Development Facilitation Team (DFT) – Review Comments

Project No: PR-2022-006568

Application For: SD-2023-00147- REHEARING OF PRELIMINARY PLAT (DHO)

Project Name: 9200 Wilshire Subdivision

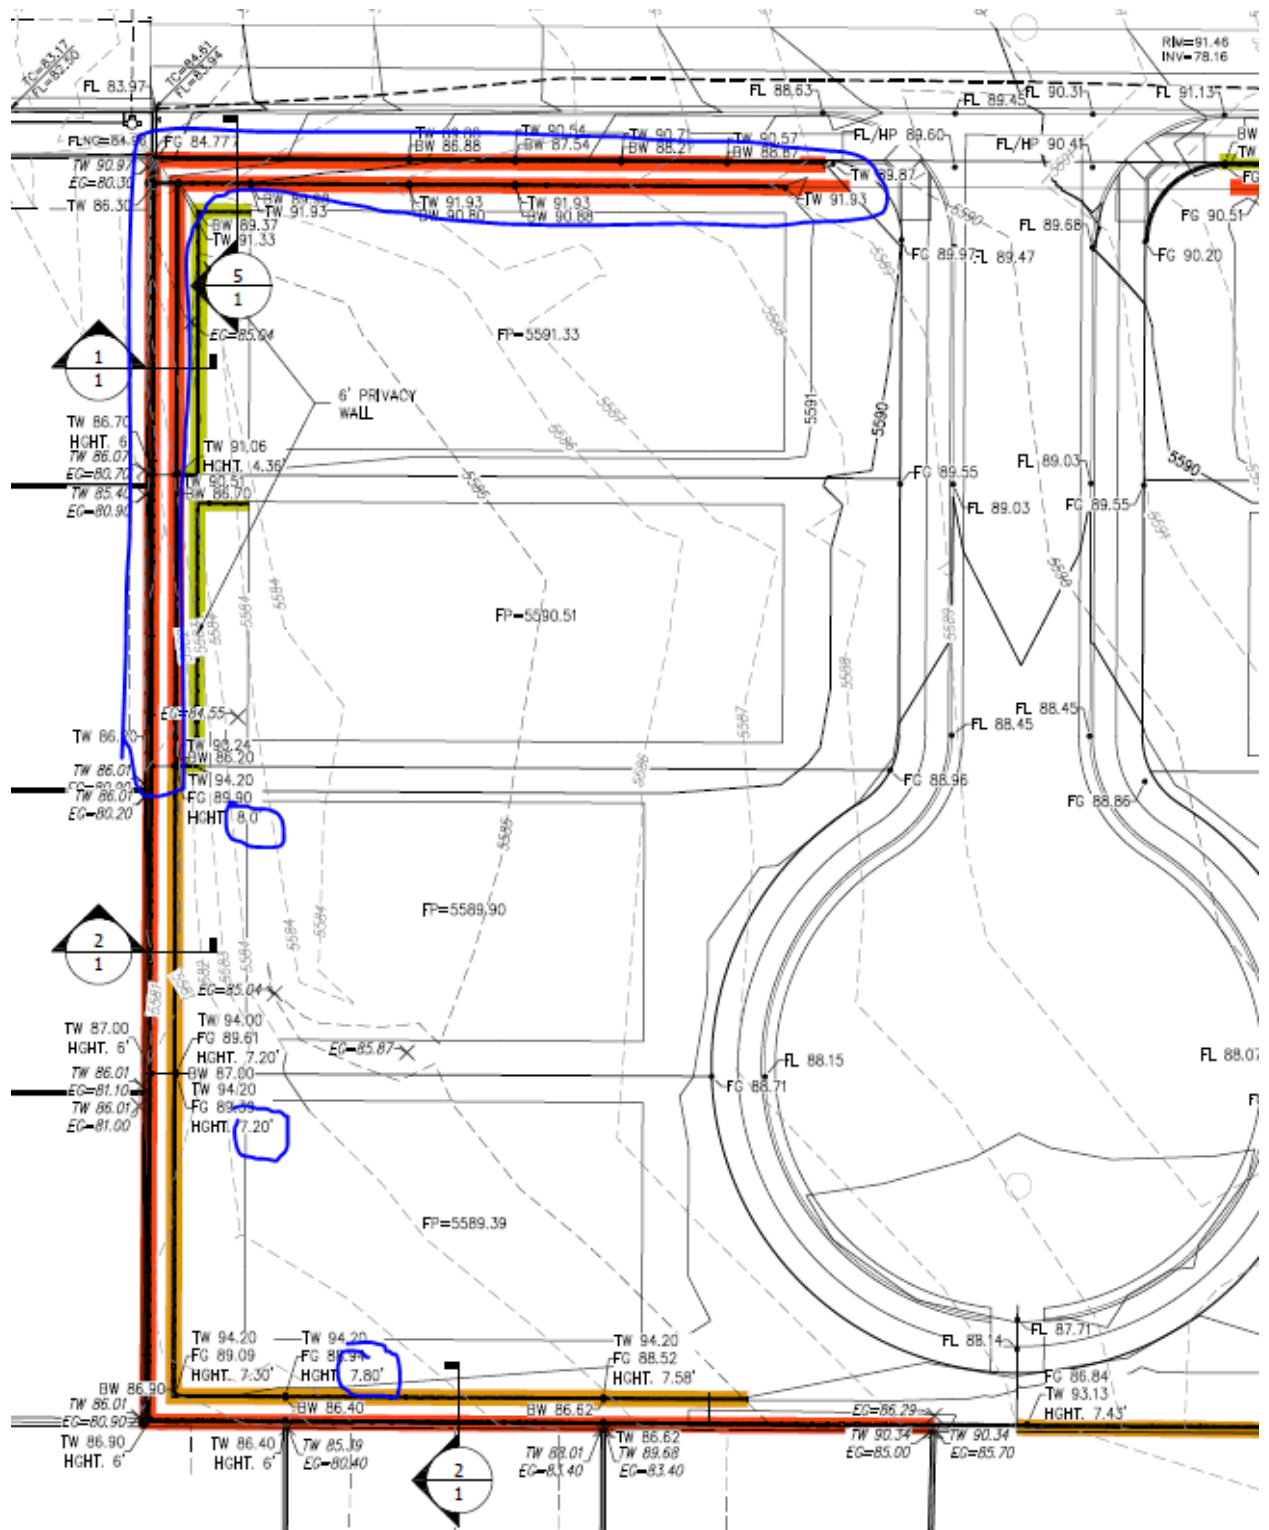
A new submittal was received on 2/2/24. The retaining walls greater than 6 feet along the western property line have been changed so that there is a second terrace. The final retaining wall heights are not listed and they need to be listed. Some of the figures remain confusing. Please clean up this exhibit for clear review of retaining wall heights AND show the height of a joint retaining/privacy wall that is retaining wall. All walls must be compliant with IDO 5-7(F) below. (Areas of concern are highlighted in blue circles below.)

- RETAINING WALL
- PRIVACY / RETAINING WALL
- PRIVACY WALL

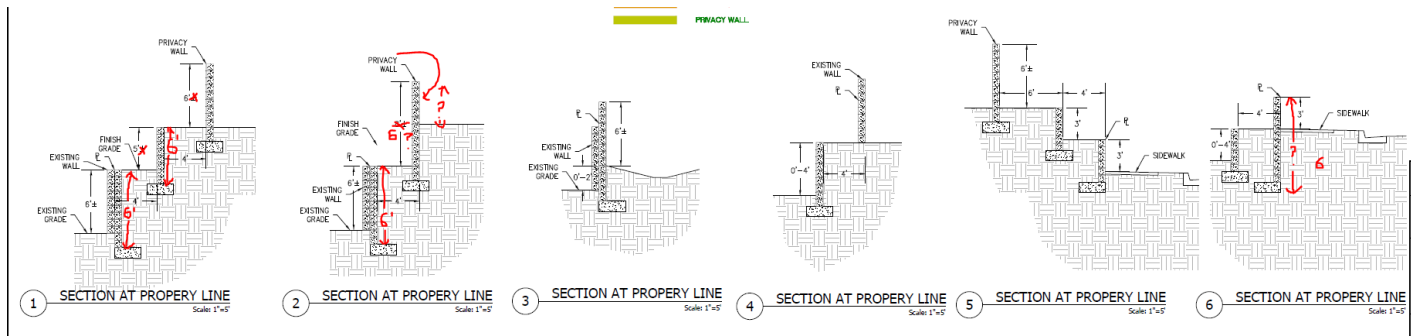
- New wall sections are shown at the bottom of the wall height diagram. **Please make the following corrections:**

Wall Section 1: The wall height for the retaining wall should be shown separately from the existing wall. The retaining wall needs to show a limit of 6 feet (do not use plus or minus; you can use minus only). For the second terrace, the retaining wall needs to show a limit of 6 feet (you can use 5-6 feet, but not 5 feet plus or minus). The Privacy Wall should show a limit of 6 feet (anything over 6 feet as the third wall would create 20-feet of total wall height in an area that is not topographically dramatic). A privacy wall of 6 feet atop 12 feet grade change is sufficient.

Wall Section 2: The wall height for the retaining wall should be shown separately from the existing wall. The retaining wall needs to show a limit of 6 feet (do not use plus or minus; you can use minus only). The second wall, shown only as Privacy Wall, needs to show the height of the portion that is a retaining wall (limited to 6 feet). Overall wall height cannot be higher than 8 feet (remove plus or minus; you can use minus only).

Wall Section 6: Show height of retaining wall.

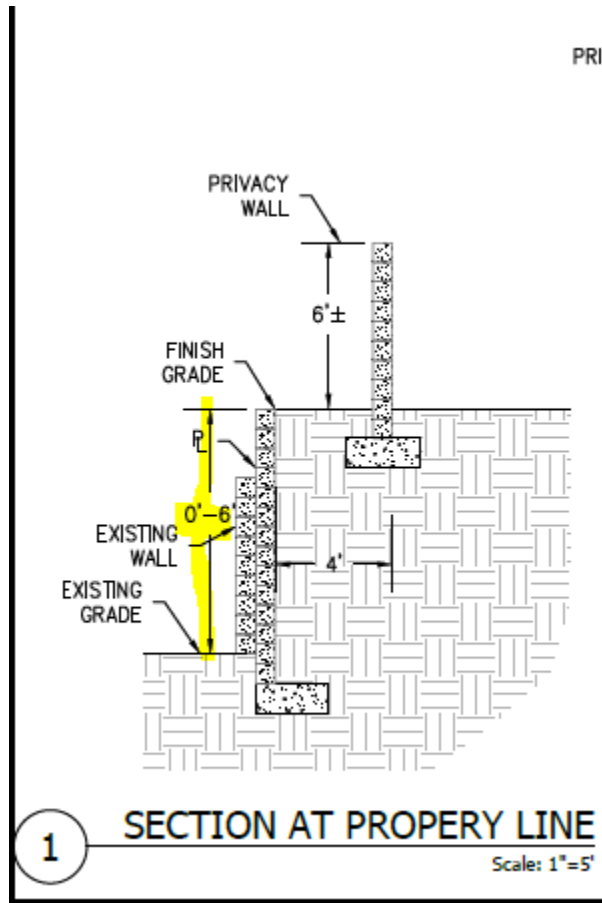
- The applicant provided a new submittal to more accurately report retaining and privacy wall heights per the DHO instruction. Some retaining walls do not meet IDO requirements. The submittal was difficult to interpret. The applicant then submitted a new submittal Monday. Some of the notable revelations from the new submittal include. (Please note wall heights circled in blue.):

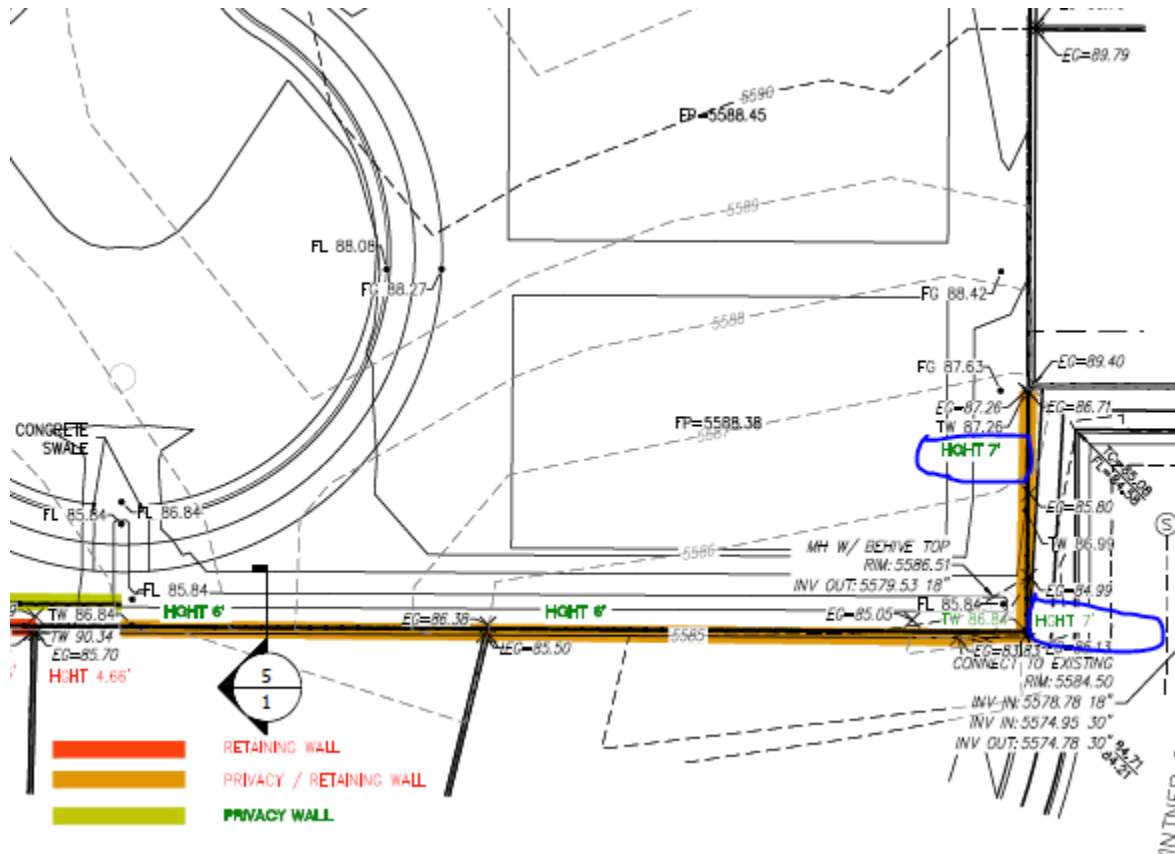
The Exhibit below is from the Applicant's original and current submittals and shows a range from 0 to 6 feet for retaining walls. The actual height shown in resubmittals reveals that the retaining walls were planned in many locations to range from 7.19-10.67 feet.

- 3) Clarification is needed for the wall in 'butterscotch' color below. The retaining portion of these walls cannot be taller than 6 feet without a terrace.
- 4) The applicant had previously shown a stacked wall, see Wall height #3 along the eastern portion of Wilshire. This wall was not in compliance with the IDO for wall height along the street-facing front or side yard. The applicant has made modifications so that the retaining wall and privacy wall are not separated by a terrace, bringing these wall sections into compliance.
